Project	IEEE 802.16 Broadband Wireless Access Working Group < http://ieee802.org/16 >
Title	Fixing mappings between primitive functions and NCMS services
Date Submitted	2007-03-15
Source(s)	Ronald Mao, Achim Brandt, Erik Colban Huawei, Siemens, NextWave rmao@huawei.com
Re:	Contribution on comments to IEEE 802.16g/D8
Abstract	The contribution proposes a resolution to the Sponsor Ballot comment 106.
Purpose	Adoption
Notice	This document has been prepared to assist IEEE 802.16. It is offered as a basis for discussion and is not binding on the contributing individual(s) or organization(s). The material in this document is subject to change in form and content after further study. The contributor(s) reserve(s) the right to add, amend or withdraw material contained herein.
Release	The contributor grants a free, irrevocable license to the IEEE to incorporate text contained in this contribution, and any modifications thereof, in the creation of an IEEE Standards publication; to copyright in the IEEE's name any IEEE Standards publication even though it may include portions of this contribution; and at the IEEE's sole discretion to permit others to reproduce in whole or in part the resulting

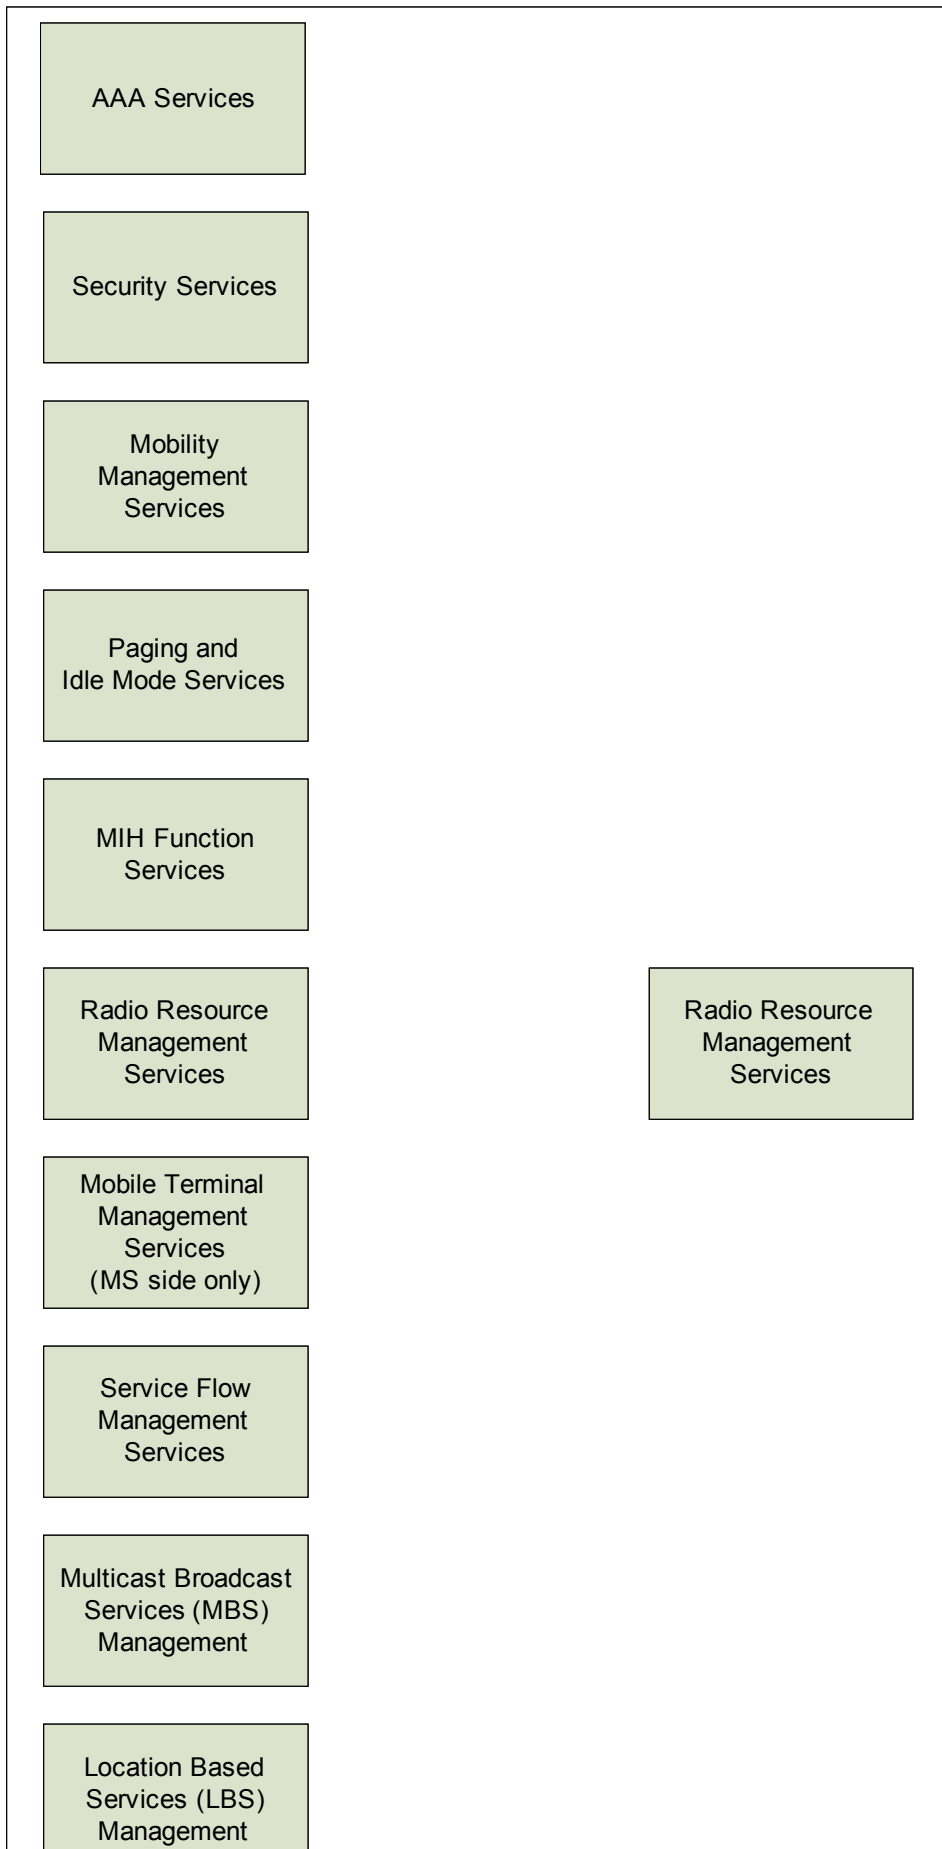
Summary of how it is today and how it should be, in tabular form; required changes are shown by yellow background:

14.2.5.3 MIH Ctrl protocol procedures	MIH Function Services	C-MIH-IND	
14.2.6 RRM	RRM Services aka RRC (Radio Resource Controller)	C-RRM-REQ/RSP/IND	
14.2.7 Network Entry&Exit Mgmt	“SF Management Services” and Mobility Management Services (14.2.7 talks of “upper layer entity”)	C-NEM-REQ/RSP/IND	(p.118 line 1: Wrong Destination; should be NCMS(BS)).

Figure 1a: Illustration of the Network Control and Management System (Informational)

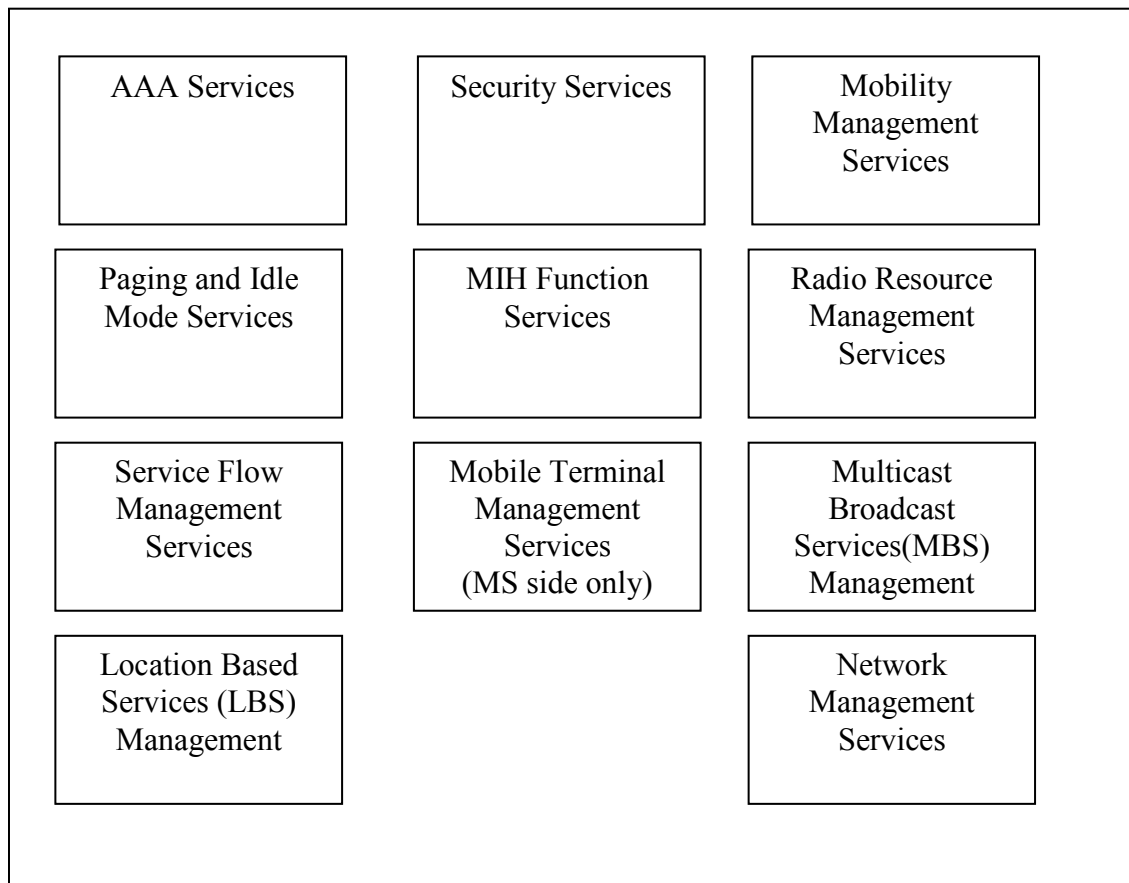
1) Add box “Mobile Terminal Management Services (MS side only)” in Figure 1a.

[*Modify Figure 1a as follows*]
